PUBLIC UTILITIES COMMISSION

RE: Request for Additional Data – Certificate of Public Convenience and Necessity for the Sycamore-Peñasquitos 230 Kilovolt Transmission Line Project – Application No. A. 14-04-011

REQUEST FOR ADDITIONAL DATA: DATA NEEDS FOR THE SYCAMORE-PEÑASQUITOS 230 KILOVOLT TRANSMISSION LINE PROJECT APPLICATION (A. 14-04-011)

Attachment A: Segment B Work Area

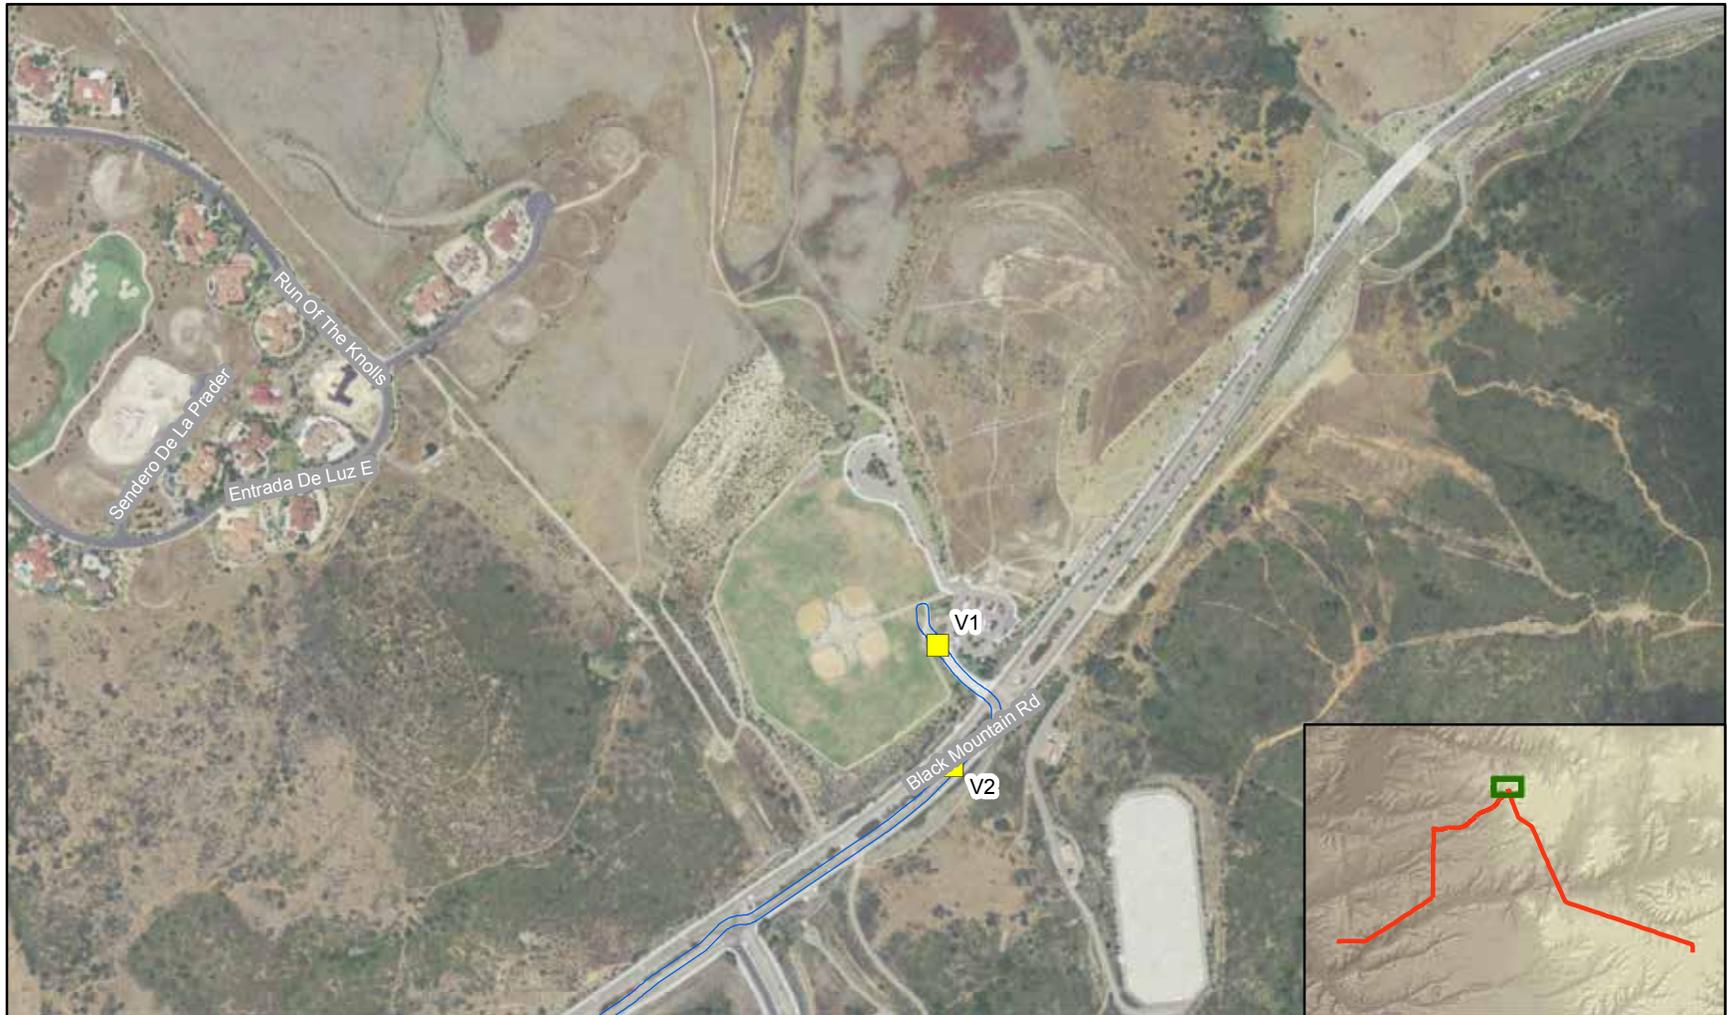
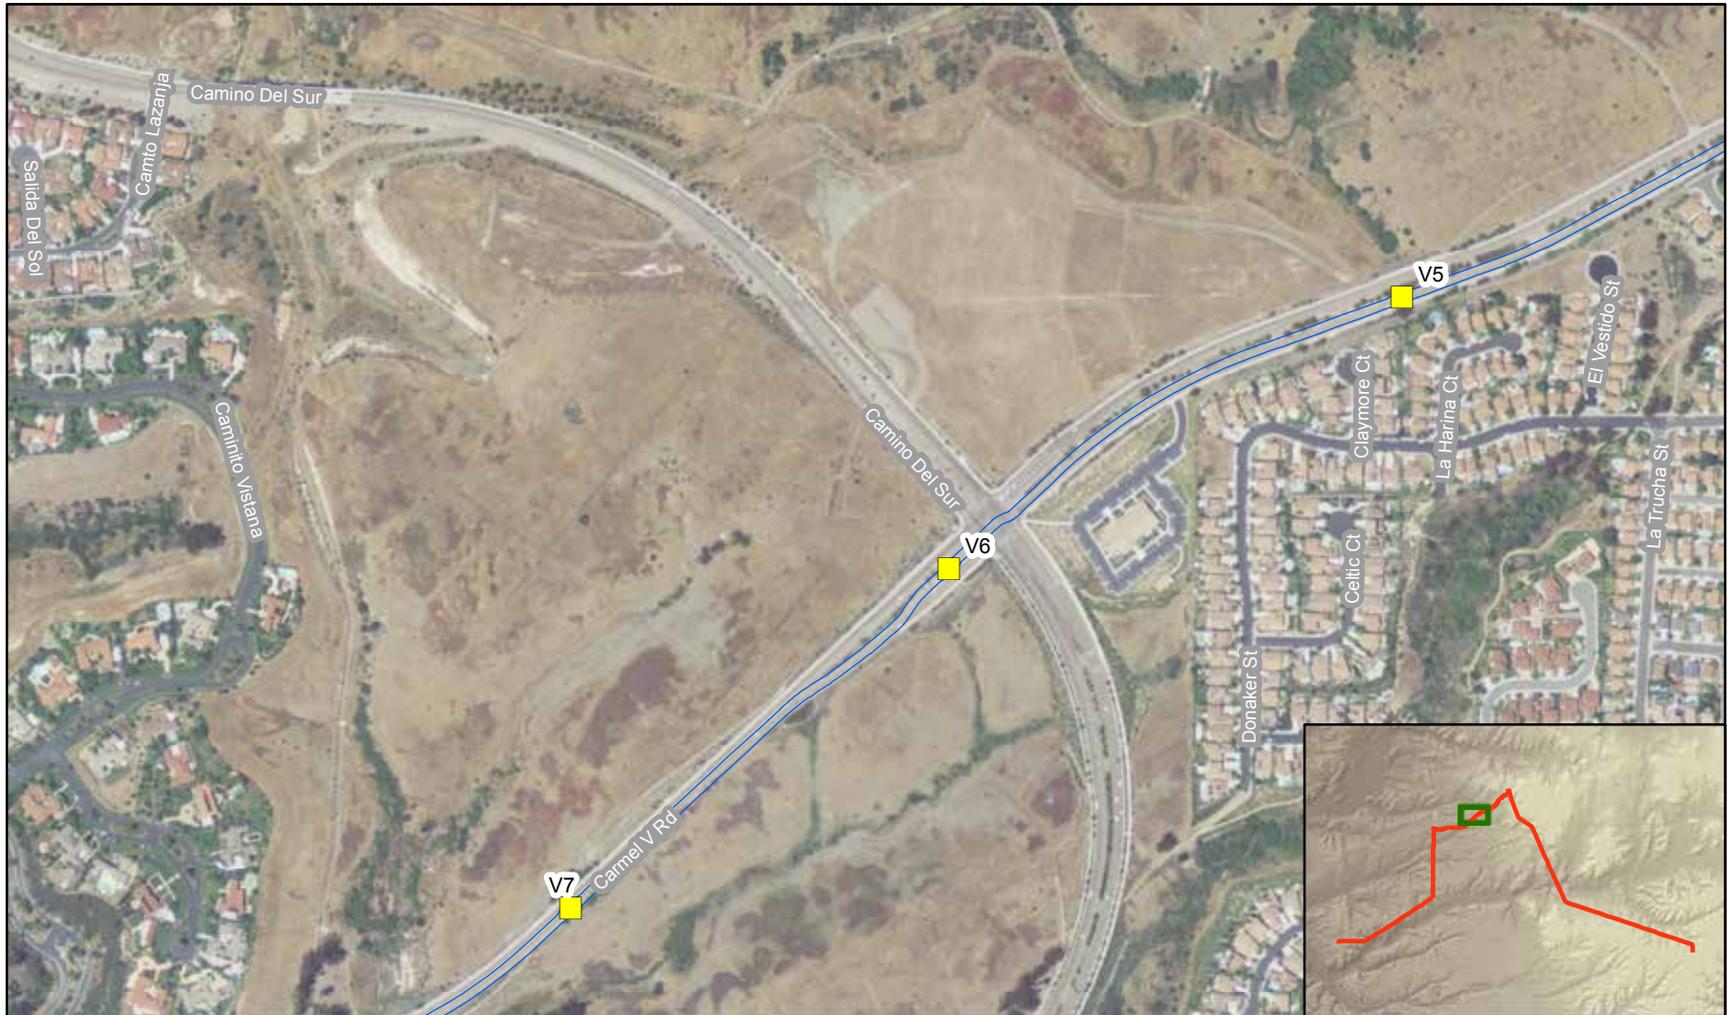
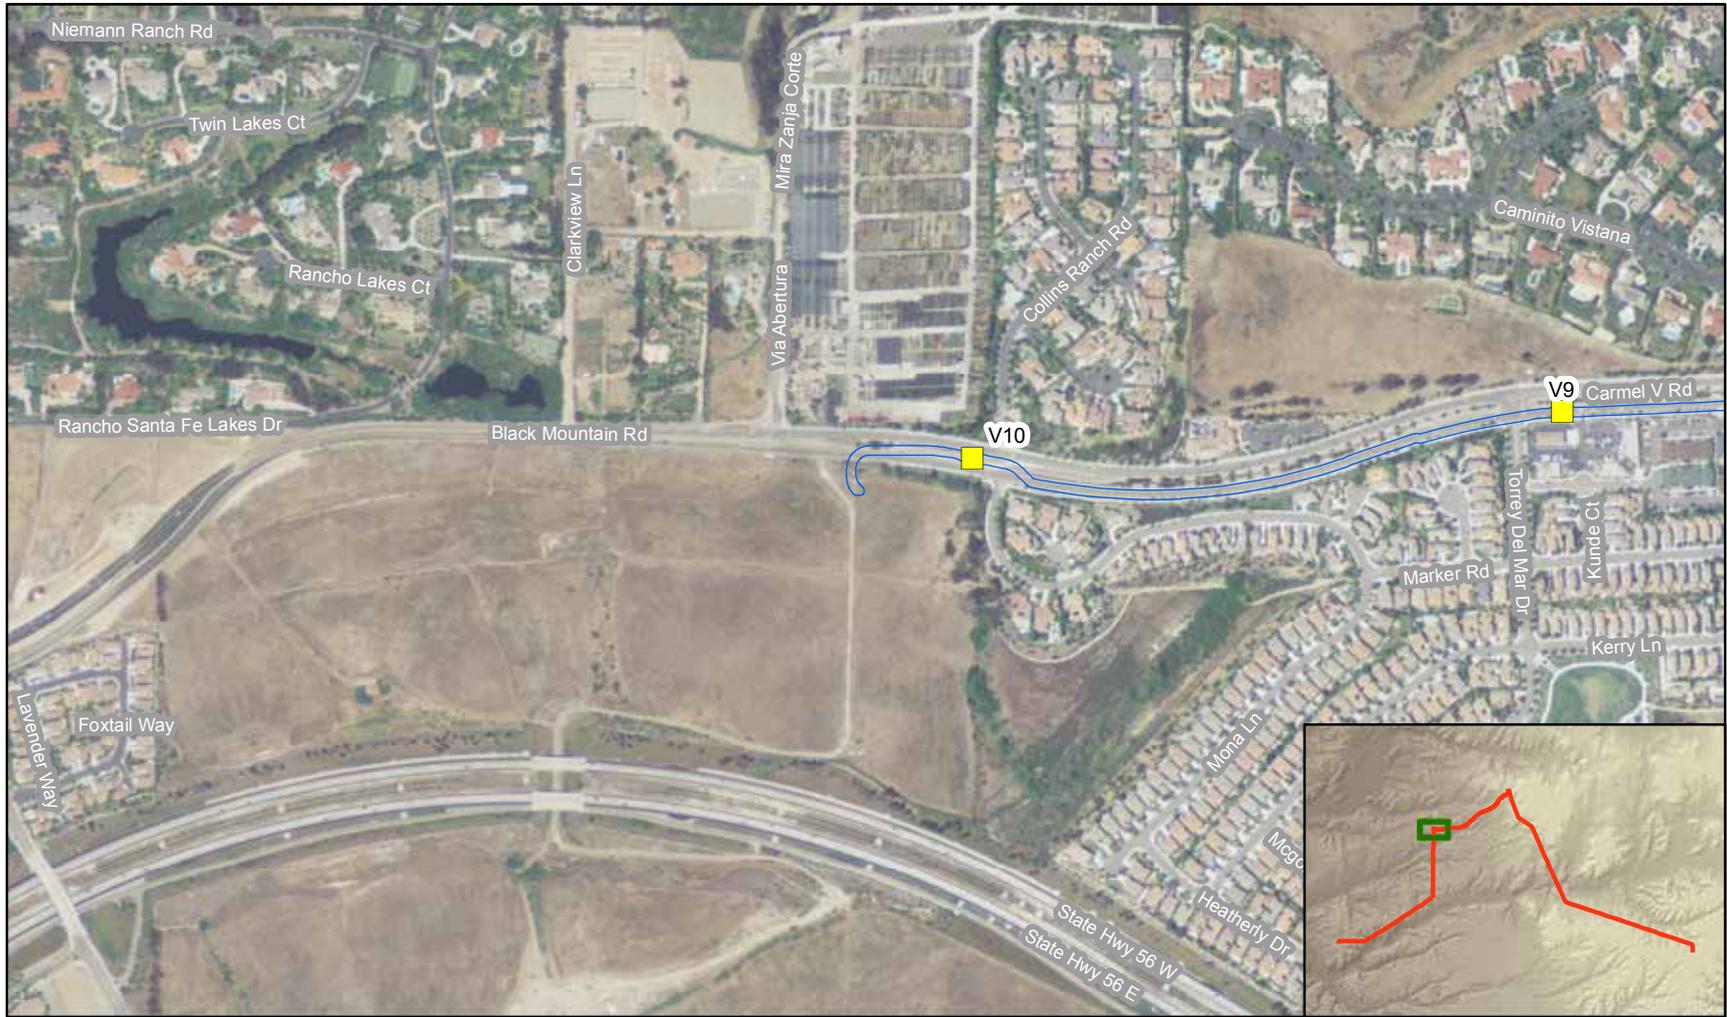
4	Deficiency Report #1; Item 7(d)	Verify the proposed alignment and work area for Segment B. SDG&E modified the alignment for Segment B in the GIS data provided with response to Deficiency Report #1. Item 7(d) in response to Deficiency Report #1 states that the work area for Segment B is approximately 30 feet wide. Panorama has placed a 15 foot buffer on either side of the proposed alignment to show the 30-foot-wide workspace (Attachment A). It appears on the GIS that the proposed work space may overlap with the landscaped median in some parts of the road and may require removal of trees. SDG&E stated during the July 15, 2014 site visit that the City of San Diego has requested that SDG&E minimize impacts to the landscaping.

#	PEA Section, Page #	Data Need
		<p>Please review the proposed alignment and 30-foot-wide workspace (Attachment A). Either provide confirmation that SDG&E would like CPUC to analyze this alignment location in the EIR or provide a revised alignment and workspace area for analysis. In areas where the Segment B alignment overlaps with the landscaped median either describe the methodology for avoiding impacts to the landscaping, or define the number of trees that occur within the landscaped median, and which trees will be removed as a result of the undergrounding.</p>
5	Deficiency Report #1, Item 11	<p>Provide the peak number of workers that will be working on the project during construction.</p> <p>Response to Deficiency Report, Item #11, provides the number of estimated workers for construction of each component; however, we need additional clarity as to which segments would be constructed simultaneously, if any. How many workers will be arriving at the site during a peak workday?</p>
